# Rationale for final NSW REZ Access Standards

Accompanying document to the  
final NSW REZ Access Standards intended  
to apply to Central West Orana REZ

July 2022

Changes to Reactive Power Capability.

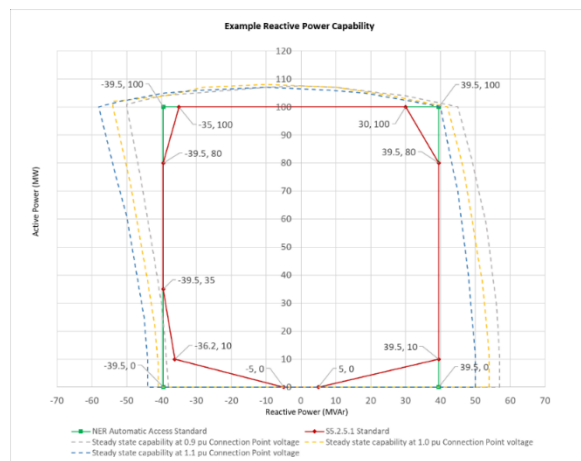
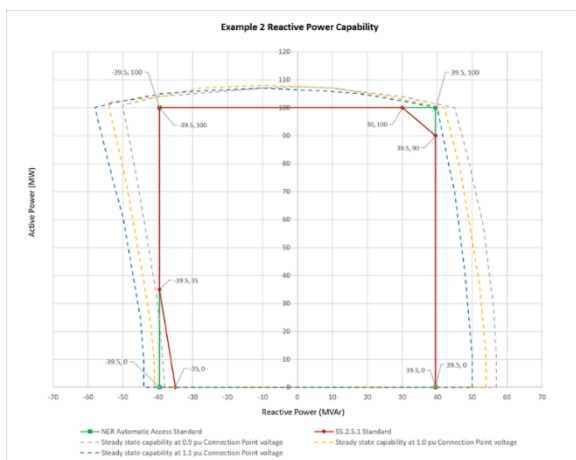
Draft Reactive Power Capability:

Final Reactive Power Capability:

### Changes to capacitive reactive power requirement:

- [(1) (a) (ii)] the amount equal to the product of rated active power of the generating system and 0.395 when generating between 10% and 80% of the rated active power of the generating system.
- [(1) (a) (iii)] the amount equal to the product of rated active power of the generating system and 0.05 when not generating active power.
- [(1) (a) (iv)] the amount defined by lines between the capabilities specified at:
  - 80% of the rated active power and the rated active power of the generating system; and
  - 10% of the rated active power and when the generating system is not generating active power.

### Changes to inductive reactive power requirement:

- [(1) (b) (ii)] the amount equal to the product of rated active power of the generating system and 0.395 when generating between 35% and 80% of the rated active power of the generating system.
- [(1) (b) (iii)] the amount equal to the product of rated active power of the generating system and 0.362 when generating at 10% of the rated active power of the generating system;
- [(1) (b) (iv)] the amount equal to the product of rated active power of the generating system and 0.05 when not generating active power; and
- [(1) (b) (v)] the amount defined by lines between the capabilities specified at:
  - 80% of the rated active power and the rated active power of the generating system;
  - 35% of the rated active power and 10% of the rated active power; and
  - 10% of the rated active power and when the generating system is not generating active power.

### Rationale for final REZ Access Standard

- Clause S5.2.5.1 is typically a negotiated access standard.
- It is noted that many large generating systems (particularly large wind farms with extensive reticulation systems) have difficulty in meeting the AAS requirement, without additional reactive plant or oversizing the plant.

- Based on survey of agreed GPS:
  - it is recognised that 40–50% of generating systems have reduced capacitive reactive power capability (with respect to the AAS requirement) at higher levels of active power (top right corner)

- on the inductive side, a reduced reactive power capability on the top left corner (at rated active power) or on the bottom left corner (low active power level) is also seen across 10–20% of generator connections.

- Based on the response received from the industry stakeholders during the REZ Access Standard consultation process, it is recognised that certain types of generating systems have a minimum operating active power level, below which the reactive power capability of the generating system may be reduced due to limitations associated with the generating units.

- The final REZ Access Standard requirement for reactive power capability has been set at a level that a well-designed generating system can reasonably achieve with consideration given to network requirements, optimised generating system design and economic efficiency of the REZ.
- It is anticipated that any impact due to the reduction of the reactive power capability from the REZ generating systems could be addressed by plant providing centralised system strength for the CWO REZ.
- Technical requirements to capture temperature de-rating and reactive power at night (Q at night) capability/wind free capability are included in the REZ Access Standards in accordance with current Transmission Network Service Provider's practices.
